# Memorandum

To:	Principal Project Lead – Premium (AC) External Council Planner (DCS) Acting Development Planning Manager (AT)	
From:	Principal Planner – Strategic Development Partnerships (AT)	
Date:	20/11/2025	
Subject:	PRR00043360 - Delmore FT2 Application	
Has a meeting occurred:	Yes <input checked="" type="checkbox"/> No <input type="checkbox"/>	
When did the meeting occur:	Thursday 21 November 2025 1.00 – 2.30 pm, in-person at 138 Albert Street Council offices L14 R 8  [REDACTED]	
		Vineway Vineway B&A B&A Commute Don McKenzie Consulting McKenzie & Co McKenzie & Co Public Works Advisory
Site Address:	Wainui, Rodney Auckland	
AUP Zoning:	Zone <ul style="list-style-type: none"><li>Future Urban Zone</li></ul> <b>Designations:</b> <ul style="list-style-type: none"><li>NoR6</li></ul>	
Proposal:	<ul style="list-style-type: none"><li>The proposed development involves a master planned primarily residential development comprising arterial, collector, local roads, JOALS, and provision for active modes.</li></ul>

Thank you for the opportunity to provide further commentary on the pre-application for the Delmore Proposal (proposal) located at Wainui. As part of AT's review for Auckland

### 4. Lack of Integration between Delmore and Ara Hills

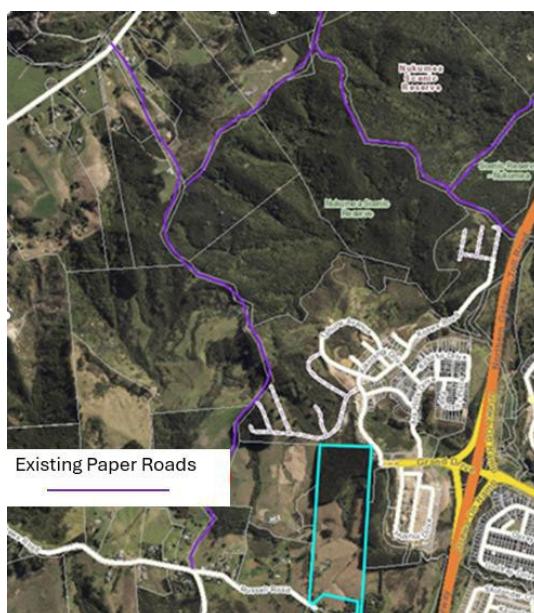
When the Ara Hills Precinct Plan is overlaid with the Delmore Fast Track #2 proposed road network it is apparent that there is a lack of integration between the two networks. Prior to lodging the formal fast track application both Delmore and Ara Hills should privately agree a road network that is integrated and agreement in principle is reached on the levels of the two roads being connected (acknowledging the limitations provided by topography in some locations may prevent future connections). The following changes should be considered by both applicants in Delmore and Ara Hills:

Delmore advised that they would look at what they could provide/achieve on their own and what could potentially be achieved with Ara Hills. This would include justification for the roading system and reasons why suggestions are unable to be done perhaps because of topography and alignment.

AT recommends that meetings be held with Ara Hills to enable integration of the two developments.

**Applicant response:** Refer to the memo titled “Appendix 9.1 – Auckland Transport Response Memo” which provides an assessment against each of these locations.

## 5. Paper Roads

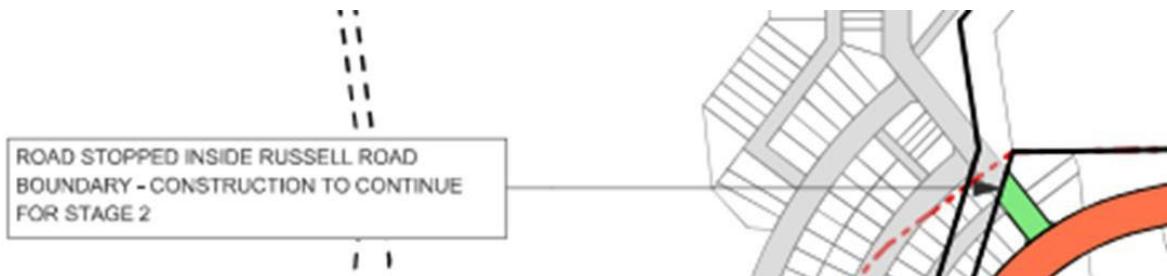
The section of paper road (now shown in blue on new plan) are part of a large network of unformed legal road as shown in purple below. It is important that this network remains fully connected.

The plan provided at the pre-app meeting with AT Property Services on 17 December 2024 relating to an intended future closed road application showed a proposed local road connecting to the unformed road and onto the NOR 6 road, which would provide continuity of access to the unformed road network. It is not clear why the proposed network has changed to connect at road 7 and the original local road shown green below has now become a JOAL.

**Applicant response:** Refer to the memo titled "Appendix 9.1 – Auckland Transport Response Memo" which provides an assessment against each of these locations.

Dec 2024 local road connecting to paper road off Grand Drive

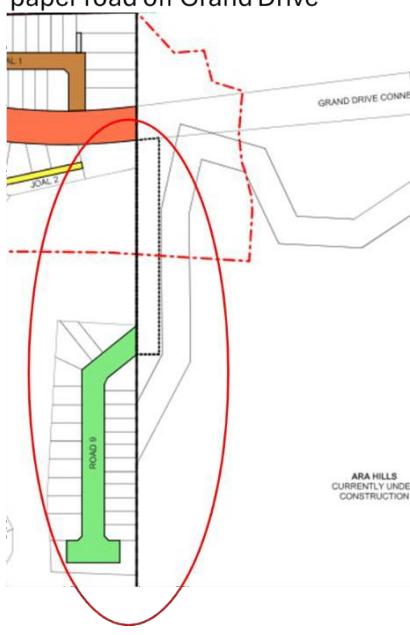
In addition, AT is concerned that the recently created paper road on the Delmore/Ara Hills boundary no longer has a direct connection through to Delmore as was previously proposed to AT. JOAL 40 was to be a public local road to connect with the existing paper road. As advised to the applicant at the pre-app meeting with AT Property Services on 17 December 2024, any proposed reconfiguration of the development site that impacts any sections of the unformed legal road on the site, will require the applicant applying for a road stopping.

Nov 2025 not connecting to recently created paper road

Delmore to provide additional information on the above points. AT would like Delmore to consider a walking link from JOAL 40 through to Grand Drive. Any such link would

Applicant response: Pedestrian access within the JOAL is proposed, which would connect to the site's eastern boundary. The applicant does not propose to construct pathways outside of the site. The road identified by AT is unformed and located within an area of existing native vegetation which is protected via consent notice.

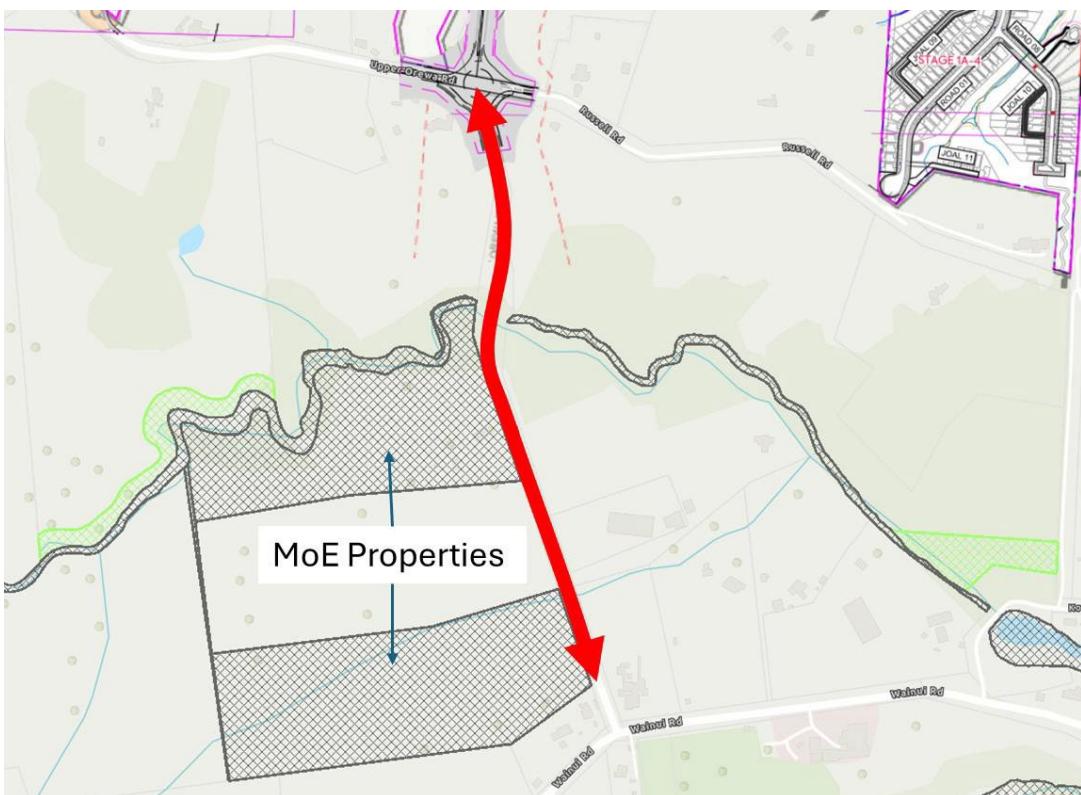
not necessarily need to follow the location of the paper road on the adjoining ARA Hills site.

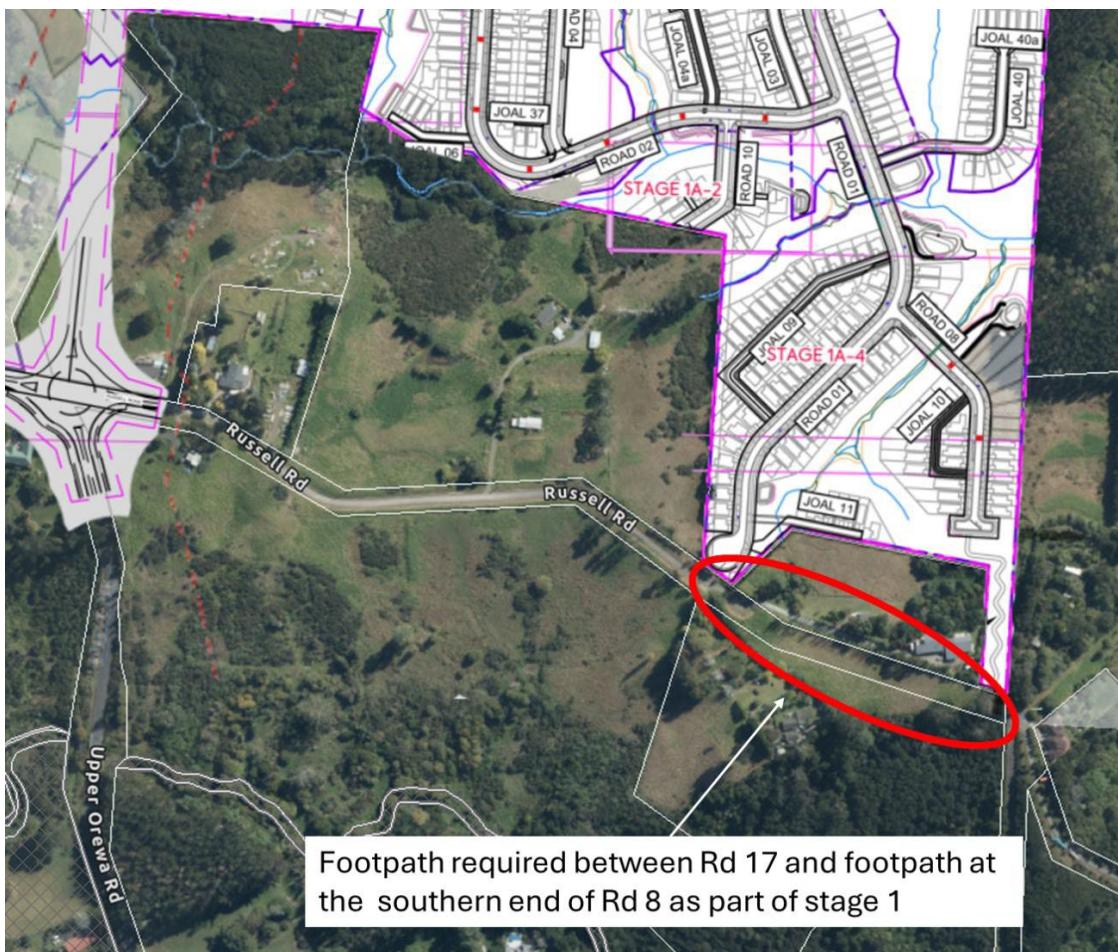
AT is supportive of the proposed active mode path along Upper Orewa Rd and Russell Road. However, the path will need to extend along the Russell Rd Paper Road to the eastern boundary connecting to the footpath at the southern end of Rd 8. This section of footpath should be constructed as part of stage 1 rather than prior to the opening of the Rd 17/Upper Orewa Rd roundabout.

Delmore proposes a condition and is to look at extending the interim active mode path to the path on Road 8 as part of stage 1. This area is circled in red in the above snip. The design of this interim path and the need for any lighting is to be looked at and outlined in the ITA.

Applicant response: Noted. A condition of consent is proposed to reflect this.

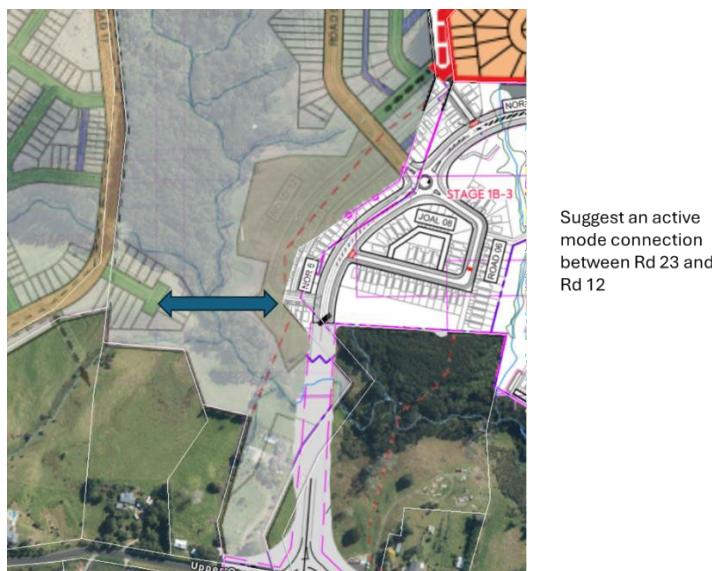
Consider as part of stage 2 a new active mode connection to connect stage 1 and stage 2 areas as per below.

Delmore advised that they are open to providing this link, but Council ecology specialists are opposed. AT would like this to be reviewed by Delmore. The area is not a SEA and without the active mode link the development will become car centric with no links to NoR6 which is likely a bus route.

**Applicant response:** A pedestrian bridge has been added to this location. Refer to the masterplan in Appendix 9. Further detail is also provided within Appendix 9.1 – Ecological Setbacks Memo.
